CITY OF YANKTON

COMMISSION MEETING

To: Amy Leon, City Manager
From: Kyle Goodmanson, Environmental Services Director
Subject: Change Order #5 Water Purification Expansion Project
Date: September 9, 2019

CHANGE ORDERPROJECT TITLE: City of Yankton Water Purification Facility ExpansionCHANGE ORDER NO.: 5PROJECT NO: City Project No. ES16-3DATE: August 15, 2019

SHEET
02A113

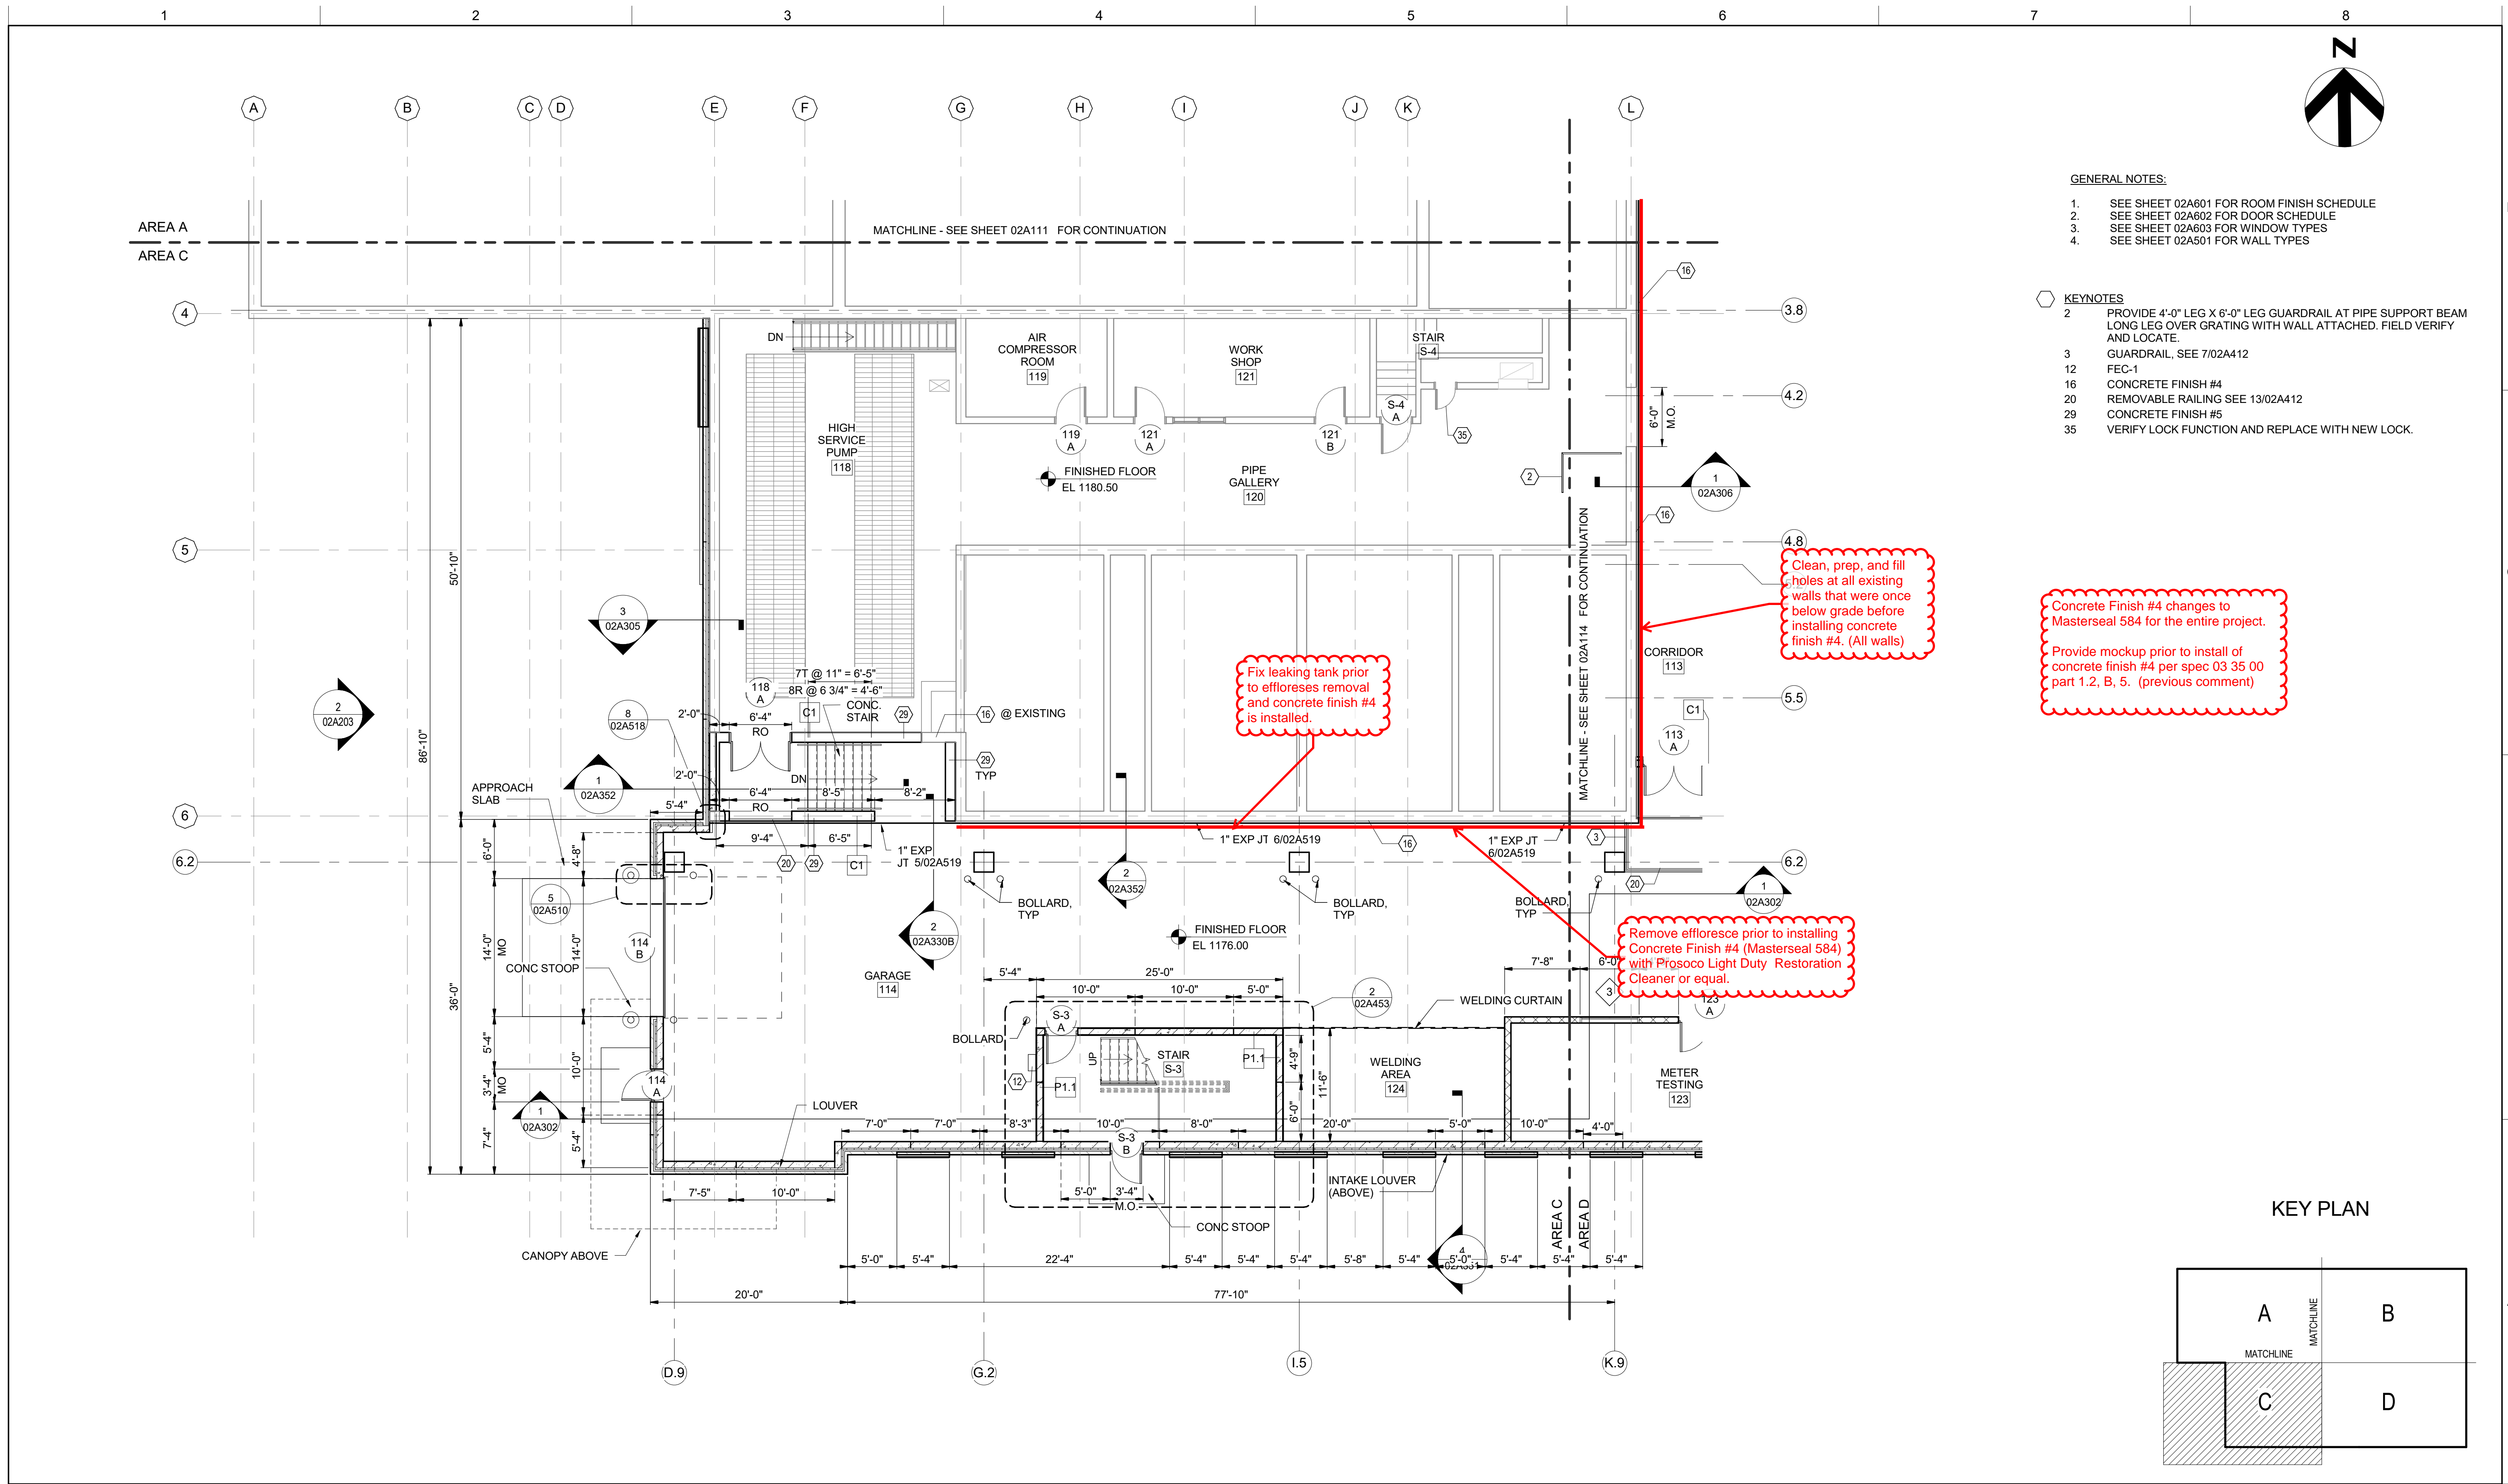
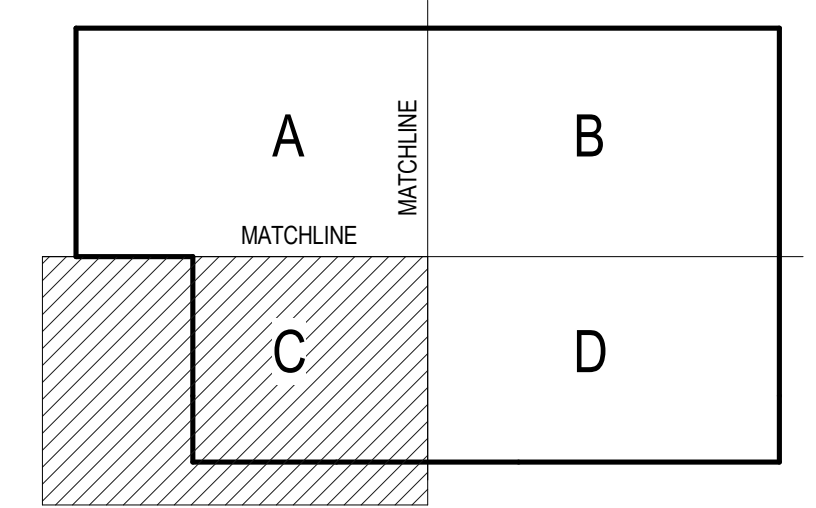
Concrete Finish #4 changes to Masterseal 584 for the entire project.

Provide mockup prior to install of concrete finish #4 per spec 03 35 00 part 1.2, B, 5. (previous comment)

Clean, prep, and fill holes at all existing walls that were once below grade before installing concrete finish #4. (All walls)

Remove efflorescence prior to installing Concrete Finish #4 (Masterseal 584) with ProsoCo Light Duty Restoration Cleaner or equal.

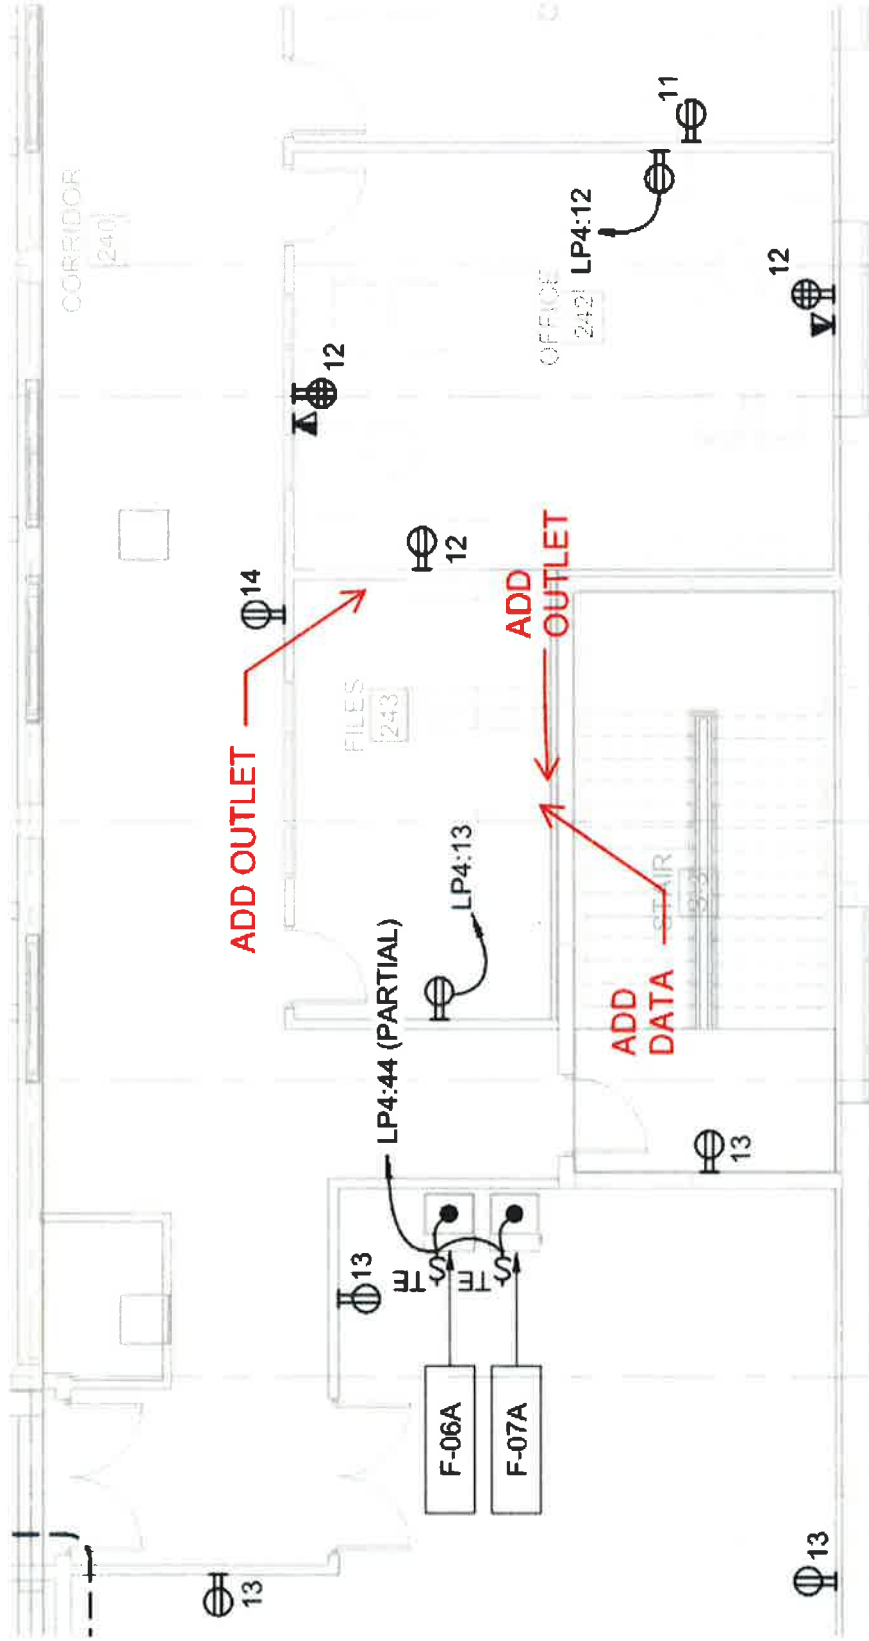
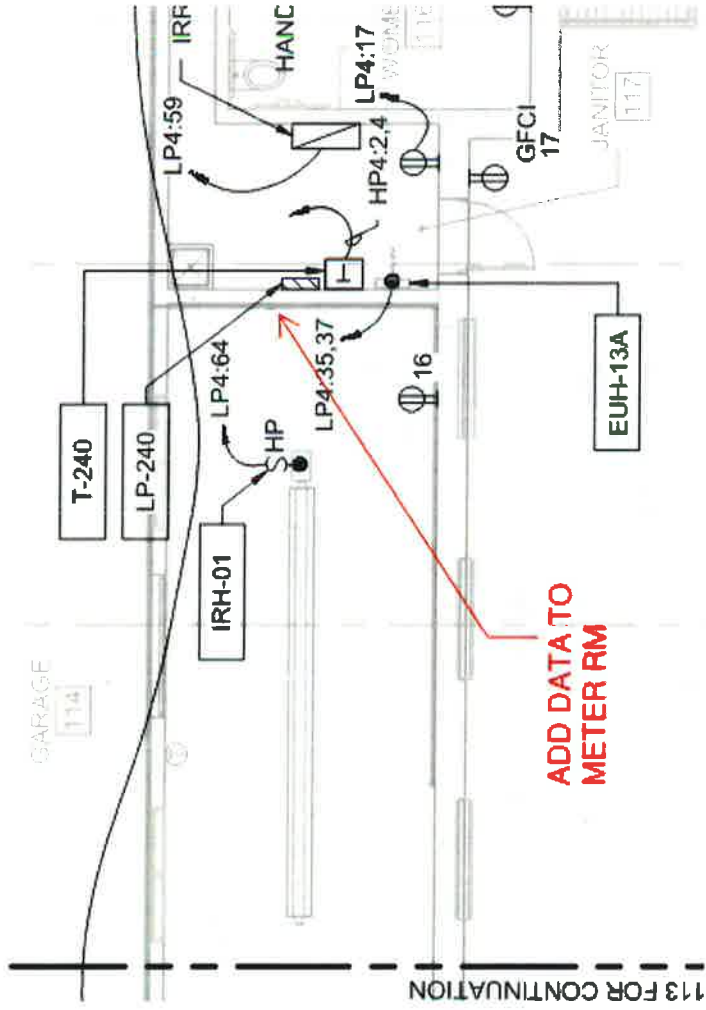
FILE ROOM 243: Add two (2) electrical outlets and one (1) data. This room may get used as a future office.

METER ROOM IN THE GARAGE: Add data drop for future computer.

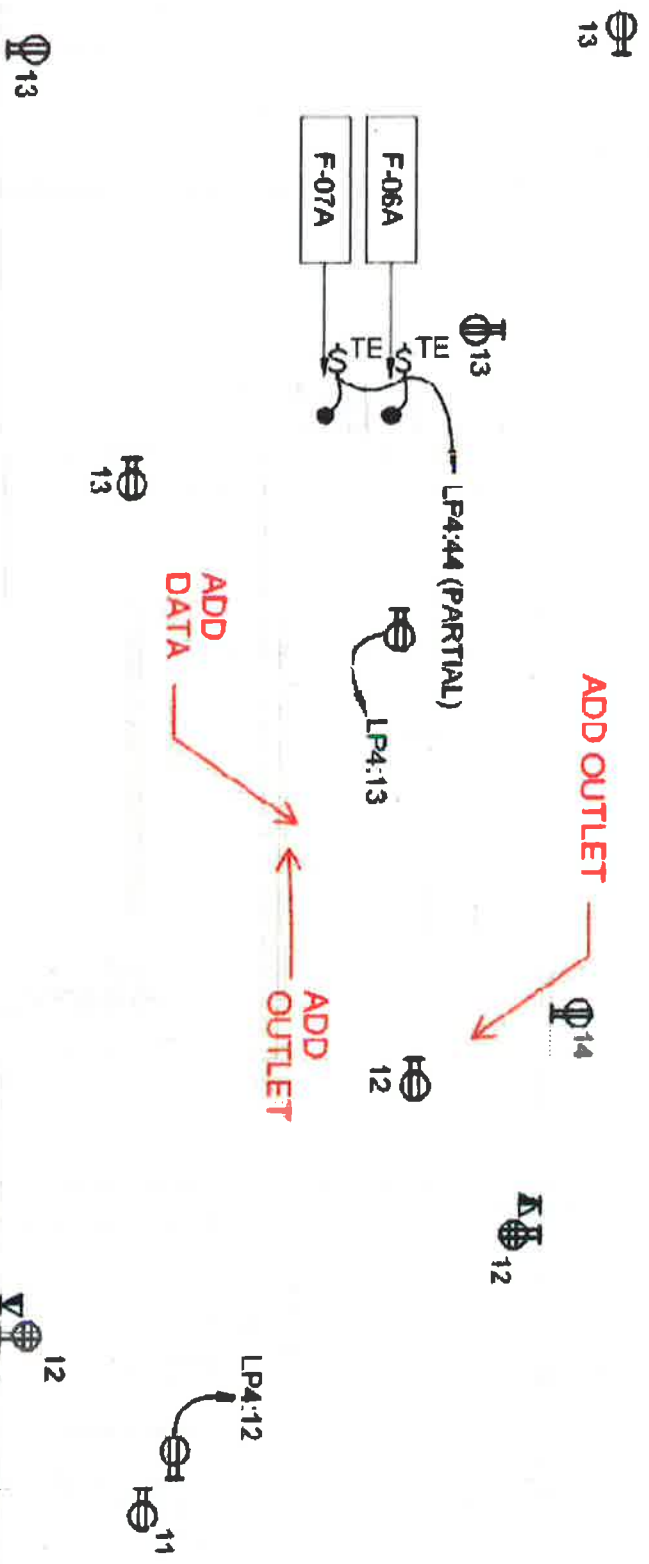
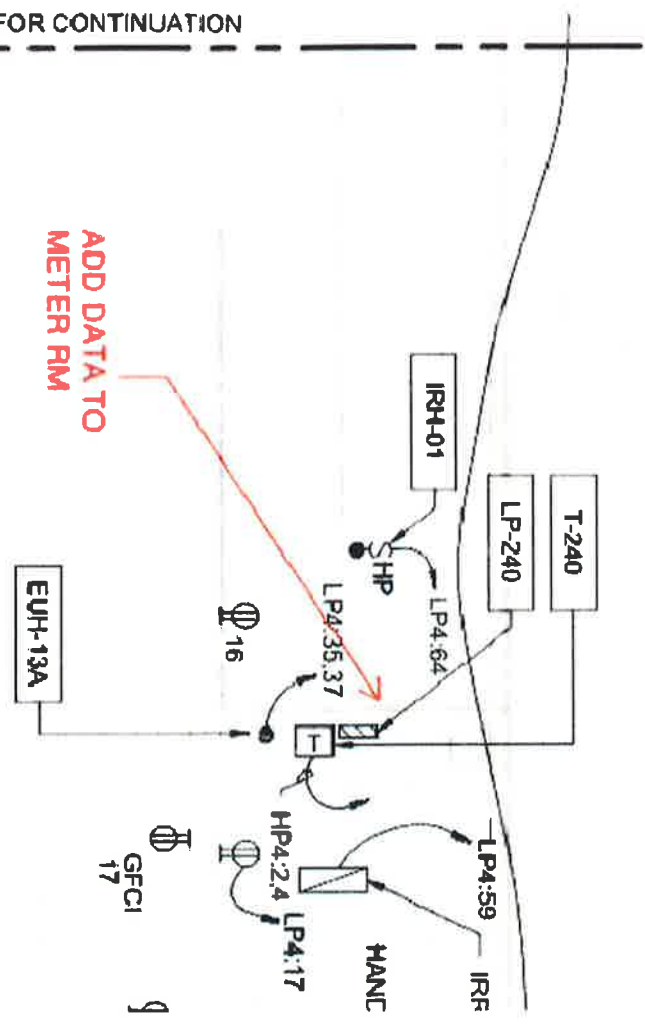
FILE ROOM 243: Add two (2) electrical outlets and one (1) data. This room may get used as a future office.

METER ROOM IN THE GARAGE: Add data drop for future computer.

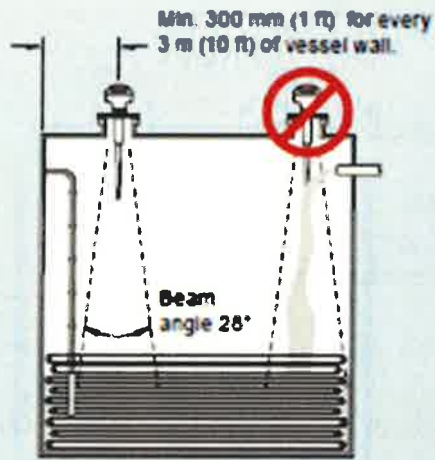
I was also thinking it might be better to have the level sensor located near the ladder. I don't think the spares are near the ladders on the tanks. So it is probably better to use the bulkhead fittings you proposed in your original email and place those near the ladders and away from the tank wall as required by the level sensor manufacturer.
